Southern California Edison Company INTERIM CALCULATION CHANGE NOTICE (ICCN)/ CALCULATION CHANGE NOTICE (CCN) COVER PAGE	CALC. NO. N-4080-003		ICCN NO./ PRELIM. CCN NO. C-1	PAGE 1	TOTAL NO. OF PAGES 21
	BASE CALC. REV. 5	UNIT 2 & 3	CCN CONVERSION : CCN NO. CCN-		CALC. REV.
	CALCULATION SUBJECT : CONTAINMENT SPRAY (CS) AND EMERGENCY COOLING UNIT (ECU) ACTUATION TIMES				
CALCULATION CROSS-INDEX <input checked="" type="checkbox"/> New/Updated index included <input type="checkbox"/> Existing index is complete	ENGINEERING SYSTEM NUMBER / PRIMARY STATION SYSTEM DESIGNATOR 1206, 1500 / BKA, GNF			Q-CLASS II	
	CONTROLLED PROGRAM OR DATABASE ACCORDING TO SO123-XXIV-5.1	PROGRAM / DATABASE NAME (S) <input type="checkbox"/> ALSO, LISTED BELOW		VERSION/RELEASE NO.(S)

1. BRIEF DESCRIPTION OF ICCN / CCN:	<input type="checkbox"/> PROGRAM <input type="checkbox"/> DATA BASE	N/A		N/A	
<p>Revise sheets 2, 3, 5, 5A, 6, 7, 8, 11, 12, 13, 14, 15, 16, 18, 21, 21A, 22, 23, and 24 (Note: the change sheets included in this ICCN include changes made to these sheets by CCN 1 on 9/20/95)</p> <p>Add sheet 7A Delete sheets (NONE)</p> <p>This change incorporates the resequencing of the Containment Emergency Fan C

FIGURE 1 - Emergency Cooling Unit Actuation Timelines

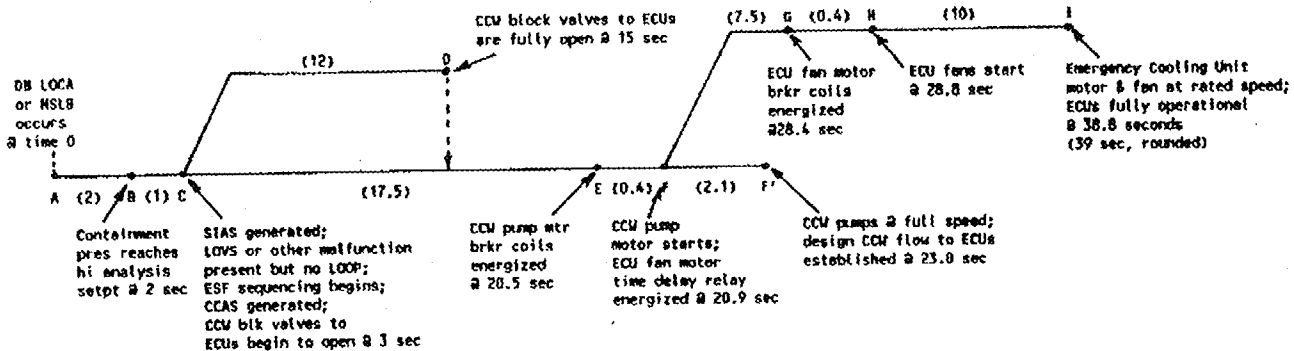
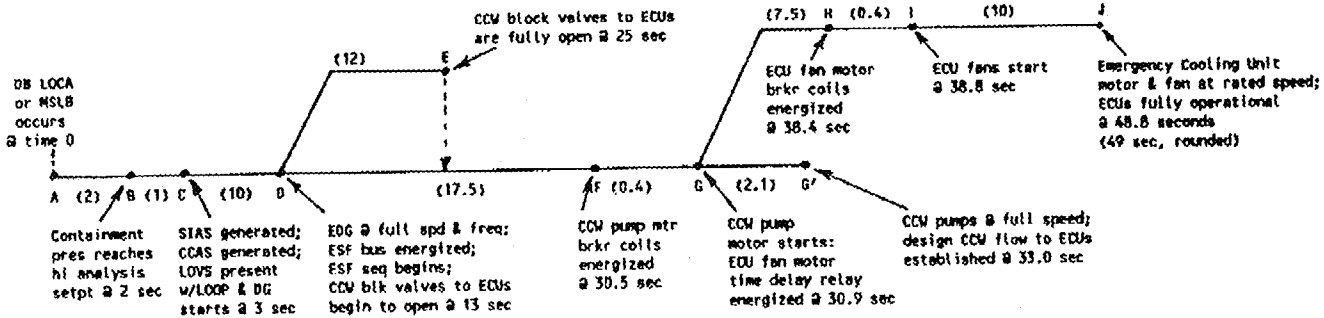
8.1.1 ECU Actuation With No Loss of Offsite Power (see Figure 1.A)

- (G) ECU fan motor breaker coils energized 7.5 sec after CCW pump motor is powered (Des. Input 4.4 & 4.12)
- (H) ECU fan motors start 0.4 sec brkr closure time (Assump. 3.2)
- (I) Emergency cooling unit motor and fan at rated speed 10 sec after brkrs close (Des. Input 4.9)

Elapsed time following DB LOCA or MSLB for full speed emergency cooling unit fan with full CCW flow
 = A + B + C + E + F + G + H + I
 = 0 + 2 + 1 + 17.5 + 0.4 + 7.5 + 0.4 + 10 = 38.8 seconds
 = **39 seconds, rounded**

8.1.2 ECU Actuation With Loss of Offsite Power (see Figure 1.B)

Elapsed time following DB LOCA or MSLB for full speed emergency cooling unit fan operation with full CCW flow
 = A + B + C + D + F + G + H + I + J
 = 0 + 2 + 1 + 10 + 17.5 + 0.4 + 7.5 + 0.4 + 10 = 48.8 seconds
 = **49 seconds, rounded**
